Coincident In-situ and Triple-Frequency Radar Airborne Observations in the Arctic

1 General comments

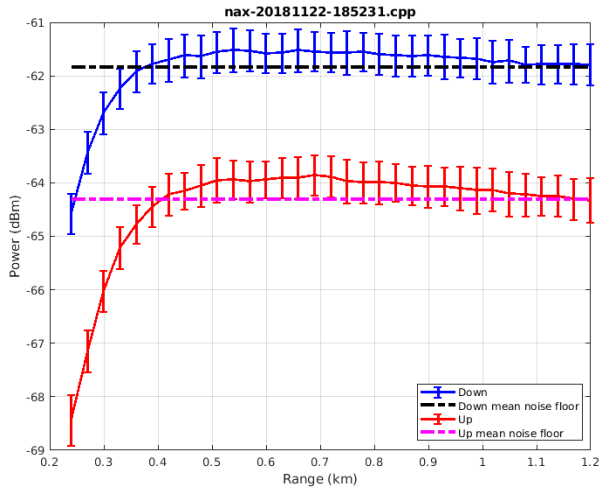
(1) You claim the data don't match in the close-range region due to limitations in the hardware. This is a bit vague, can you explain this in more detail, or consider other hypotheses and their plausibility?

In the time interval between the instant when the transmitter stops transmitting and the instant when the receiver reach to its steady state, the receiver gain can vary greatly. An example below demonstrates this phenomenon. It shows the system noise of the X-band radar as a function of range (or time). The X-band receiver gain should be stable within 1 dB standard deviation after 1 km. Usable range for the W-band (not shown here as we have to go back to raw data to generate a similar one) is about 200m.

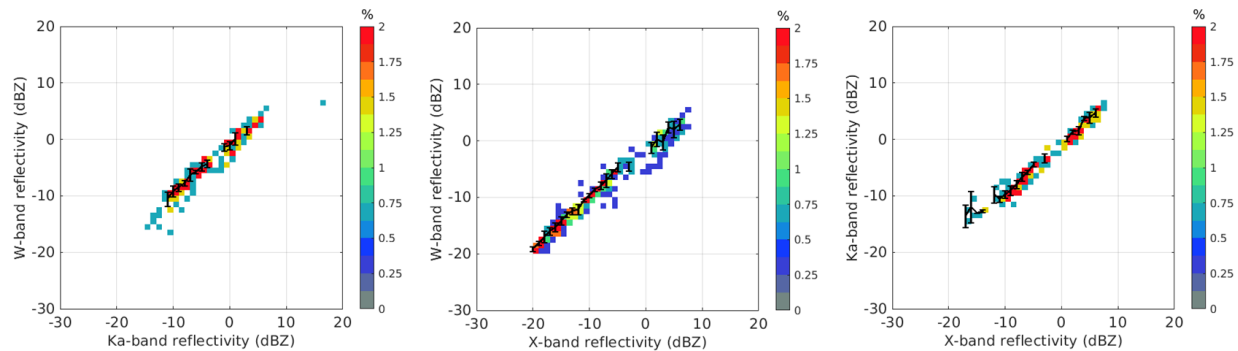
(2) Can you show direct evidence that the difference between the two radars is consistent, and quantify the (hopefully small) variability, so that we know what the uncertainty on DFR is?

In the figure below, the scatter plots of cross-calibrated W, Ka and X reflectivities at 245 m from the nadir antennas for the 22 Nov flight are shown. The data are thresholded by MVD < 300um so that $Z_{Ka} \sim Z_X$ and $(Z_{Ka} - Z_w) \sim 0.2 \text{ dB}$ (Matrosov, 1993). The black lines are the mean and error bars (one standard deviation). We found that the standard deviation of the DFRs is 0.8 dB in average. We have included this information and these plots in the revision.
